Type of application: PUD PRELIMINARY PLAN

**Staff Report**

**9 North Wild Horse  
Castle Valley Ranch PA 8 & 9 Preliminary Plan  
Resolution PZ #2024-4  
Planning & Zoning Commission – June 26<sup>th</sup>, 2024**

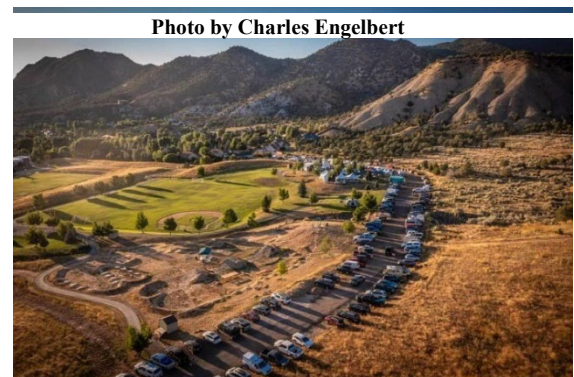
Similarly, Public Works is motivated to provide extra parking on N Wild Horse Dr to meet parking demand during larger park events. Staff believes that N Wild Horse Dr. adjacent to VIX park needs as much parking as possible. The picture exemplifies the demand swell during annual events such as Rides-and-Reggae.

The proposed ROW from the plat shows 67.5' from edge of sidewalk. This ROW is inconsistent with the design illustration on **Exhibit A, page 17**, and wider by 5.5'. Staff recommends the following design which, importantly, adds parallel parking on the east side of N Wild Horse:

<i>Applicant: ~62' ROW</i>	<i>Town: 66.5' ROW</i>
• 5' sidewalks	• 6' sidewalks
• 6' green belts	• 5.5' green belts
• 13' drive lanes	• 11' drive lanes
• 19' perpendicular parking @ VIX	• 19' perpendicular parking @ VIX
• No parking east side of NWH Dr.	• 8' parallel parking lane east side of NWH Dr.

The Town alternative would result in a 66.5' ROW with an additional 35-40 parking stalls. Further south on N Wild Horse, road design should revert back to the Town standard of 58'.
